RE: City of Blytheville Wastewater Treatment Plant Inspections

<u>ADEO</u>		WATER	DIVISION I	NSF	ECTIO	N REPORT		
	ADLQ	AF	IN: 47-00544 PI	ERMIT #: AR0022	2560		DATE: 3/8/2017		
Δ	RKANSAS	CC	OUNTY: 47 Missis	ssippi	PDS	#: 096927	MEDIA: WN		
De	partment of Environmental Quality	GF	S LAT: 35.93485	0 LONG: -89.942	2647 L	OCATION: I	Entrance		
	FACILITY INFORMAT	ION		IN	SPEC	TION INFOR	RMATION		
	E: ytheville - West WWTP ATION:			FACILITY TYPE: 1 - Municipal	5213	TOR ID#: 88 S - State			
	52 NCR 635			facility evaluation ration 1 - Unsatisfacto	ory	Com	non TYPE: npliance Evaluation		
Blytheville				(-)	NTRY TIME: 9:30	EXIT TIME: 16:45	PERMIT EFFECTIVE DATE:		
	RESPONSIBLE OFFIC	CIAL	•	1	0:35	15:10	1/1/2016 PERMIT EXPIRATION DATE:		
	E: / TITLE mes W. Sanders / Mayor						10/31/2021		
COM	PANY:		FAYETTEVILLE SHALE RELATED: N						
City of Blytheville MAILING ADDRESS:				FAYETTEVILLE SHALE VIOLATIONS: N					
	4 West Walnut St.			INSPECTION PARTICIPANTS					
CITY, STATE, ZIP: Blytheville AR 72315 PHONE & EXT: / FAX: 870-763-3602 / EMAIL:				NAME/TITLE/PHONE/FAX/EMAIL/ETC.: Thomas Jones/Pretreatment Coordinator Roger Ray/Laboratory

Inspection Response

RE: West Compliance Evaluation

Photographer:Brent WalkerDate:3/8/2017Time:1008Witness:Sarah FrasherPhoto #:6

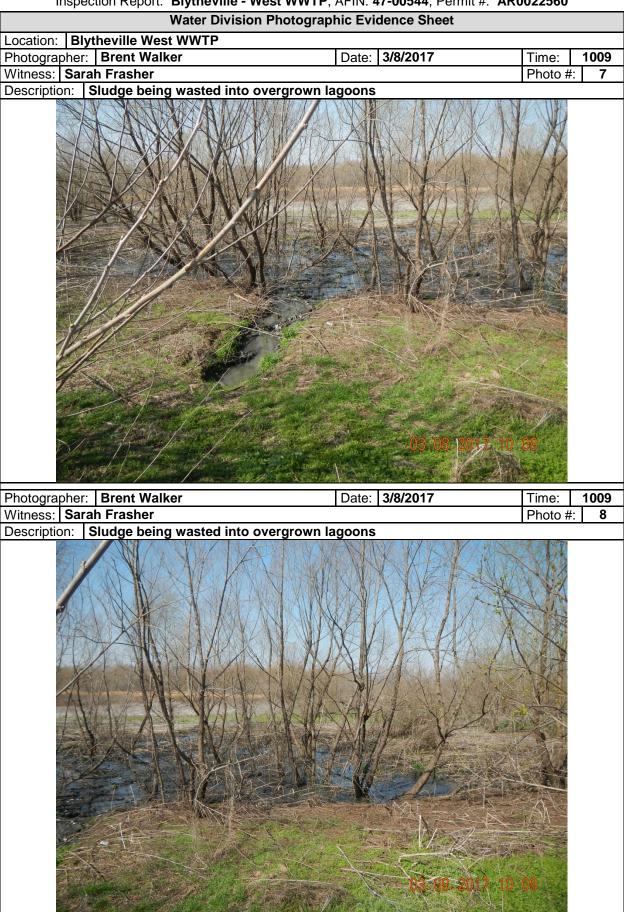
- f. The sludge storage lagoons were overgrown with vegetation (Photo 5-8). ***This is a repeat violation***
- g. The support bracket for the flow meter transducer was broken resulting in inaccurate readings. Additionally, this violates Part III Section C.2. of the permit which requires flow measurements to have a deviation of less than +/-10% from the actual discharge. A flow calibration check revealed an error of 12% at the time of the inspection.

Description: Overgrown sludge lagoons

- f. Bush hogging of levee roads will be taking care of by Operators and with reach out to contractor for bids to do the heavy debris removal.
 - g. A metal support frame was fabricated for the flow meter transducer for more accurate reading
